ALUC-22-07 (Seibel Rezone)

Determine that Application No. ALUC-22-07, (Seibel Rezone), located in Travis Air Force Base (AFB) Compatibility Zone E, is consistent with the Travis AFB Land Use Compatibility Plan (County of Solano).

[Attachment B: Travis AFB Compatibility Zones and Subject Site](#)

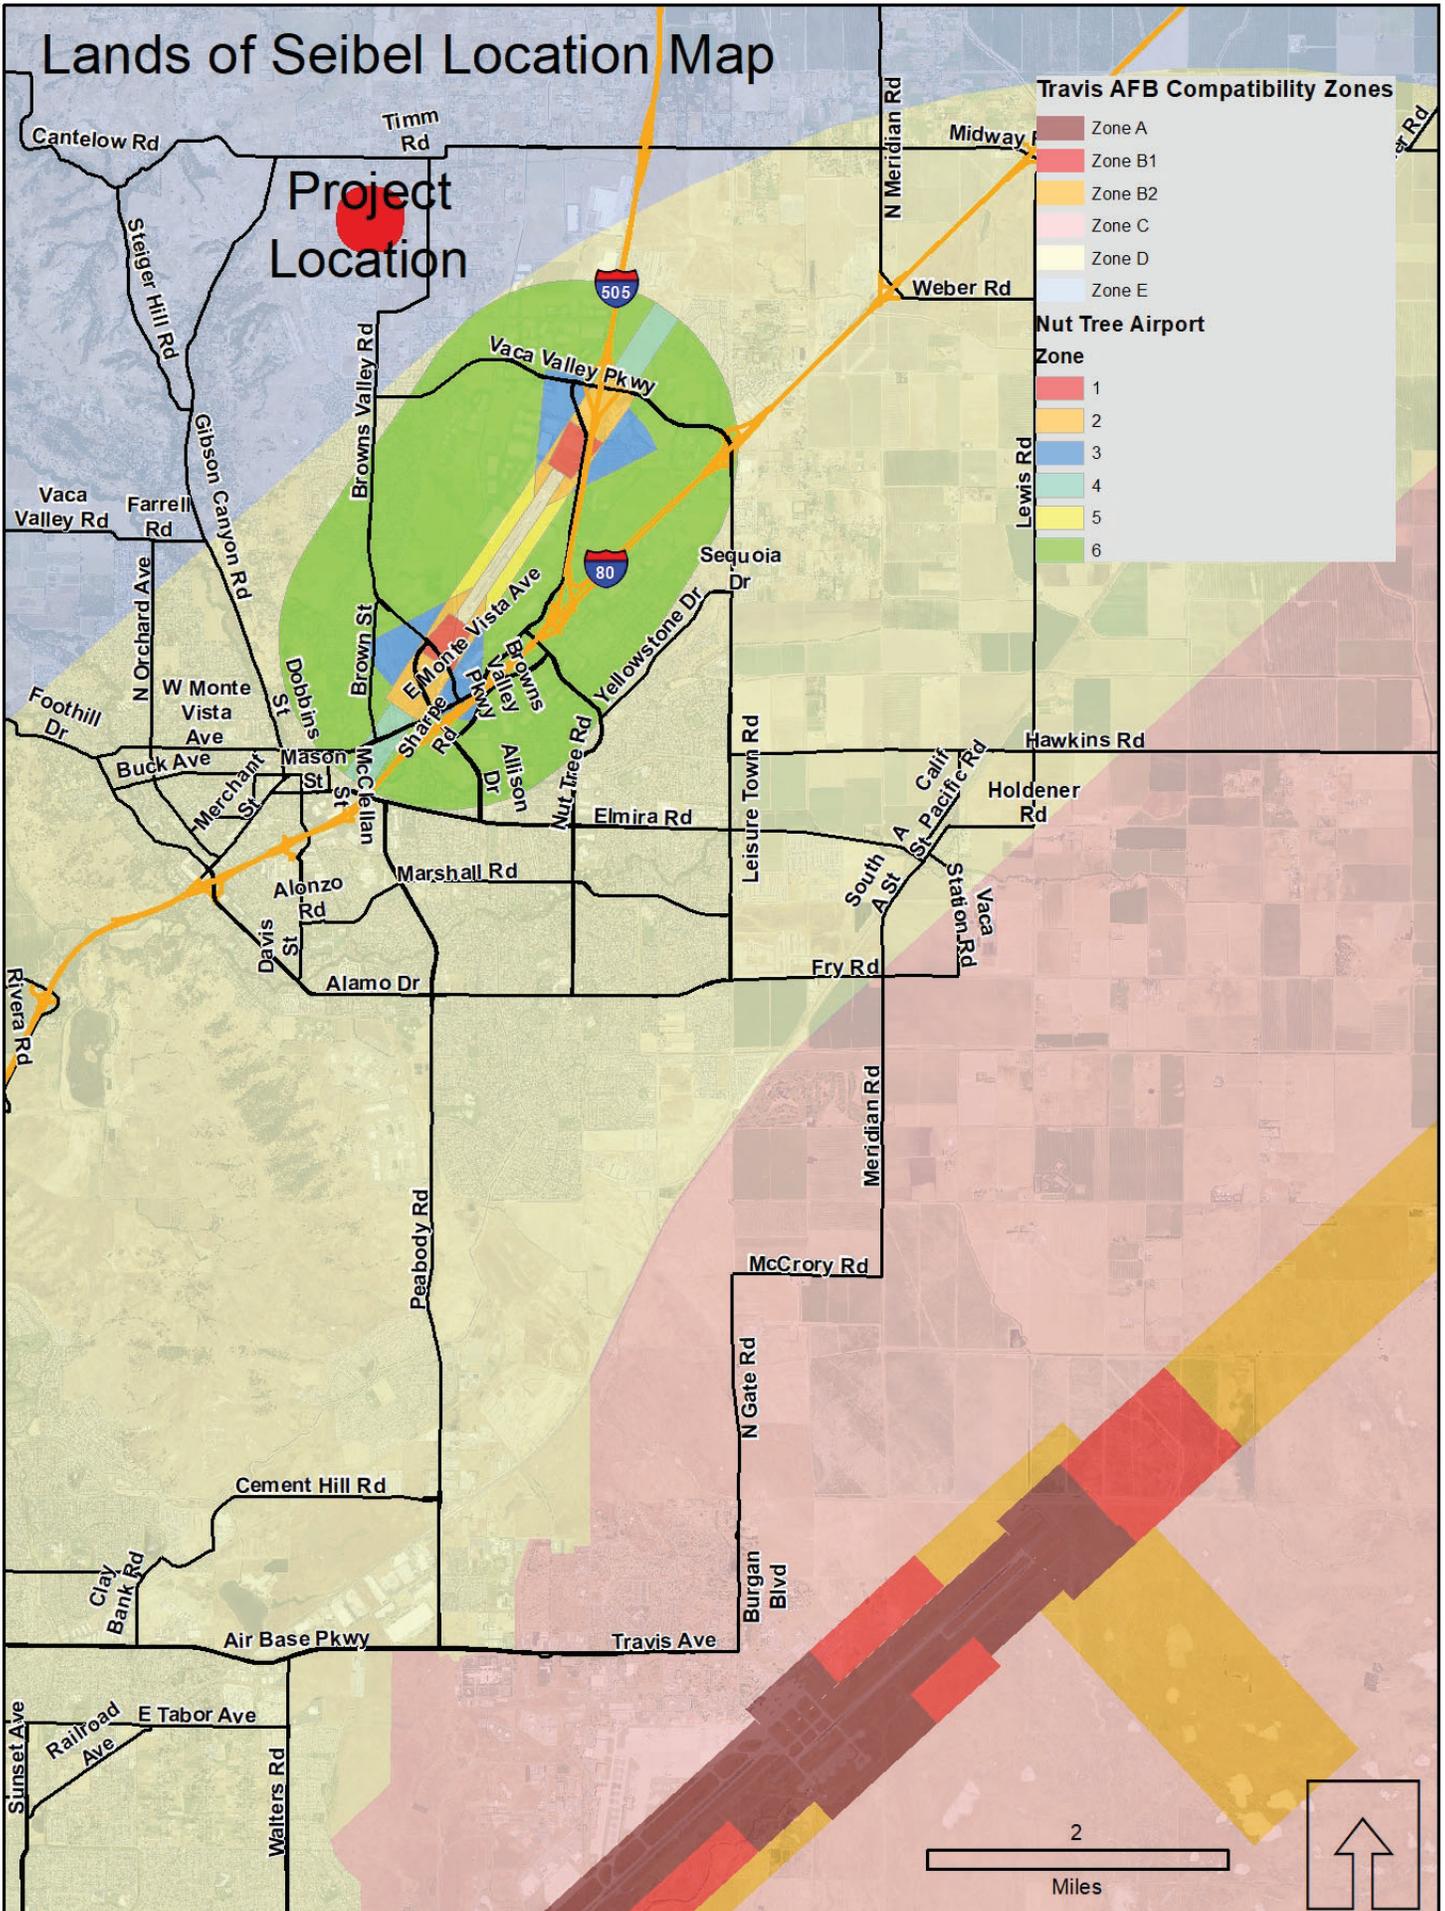
The proposed zoning change would apply to the subject site which is located within Compatibility

Zone E (see Figure 1, Attachment B). In general, Compatibility Zone E criteria require review of structural heights of objects and/or hazards related to bird attraction, electrical inference, glare and other flight hazards.

TENTATIVE PARCEL MAP
OF
LANDS OF SEIBEL
BEING A DIVISION OF PARCEL 1-D AS
SHOWN ON THE PARCEL MAP OF THE MORALES
PROPERTY, RECORDED IN THE BOOK 26 OF
PARCEL MAPS, PAGE 12, SOLANO COUNTY RECORDS
APN 0105-180-650
SOLANO COUNTY, CALIFORNIA
SEPTEMBER 2022
SCALE: 1"=60'

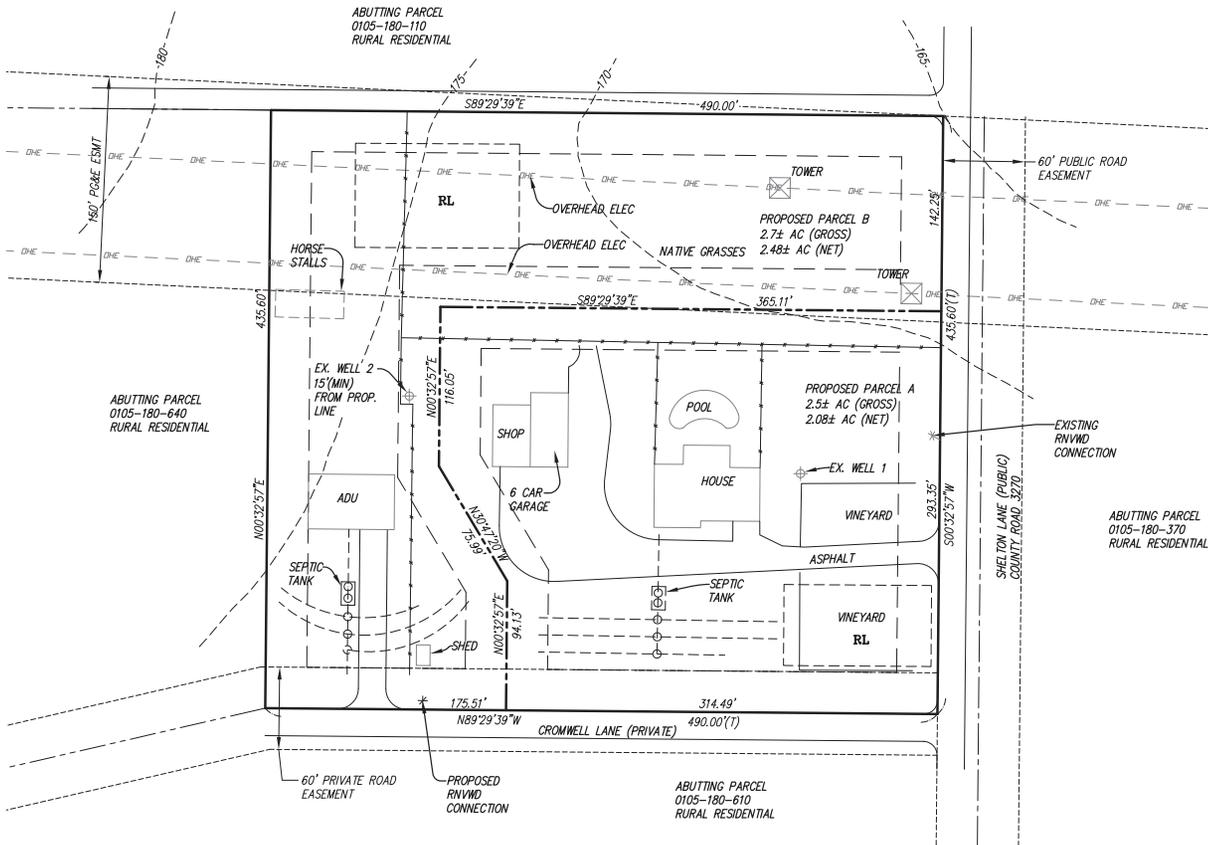
The Project is to rezone a 5.2-acre property from Rural Residential 5 acre minimum (RR-5) to Rural Residential 2.5 acre minimum (RR2.5) so that it may be subdivided. The property is located at 7181 Shelton Lane, unincorporated Vacaville. The property is already developed with a single-family dwelling and accessory structures. Access roads are provided; public water service and individual septic systems are proposed. The General Plan designation is Rural Residential 1-10 acres per unit; and the rezone request would allow densities consistent with the General Plan policy. A schematic and parcel map showing the proposed zoning change and subdivision are included in Attachment C.
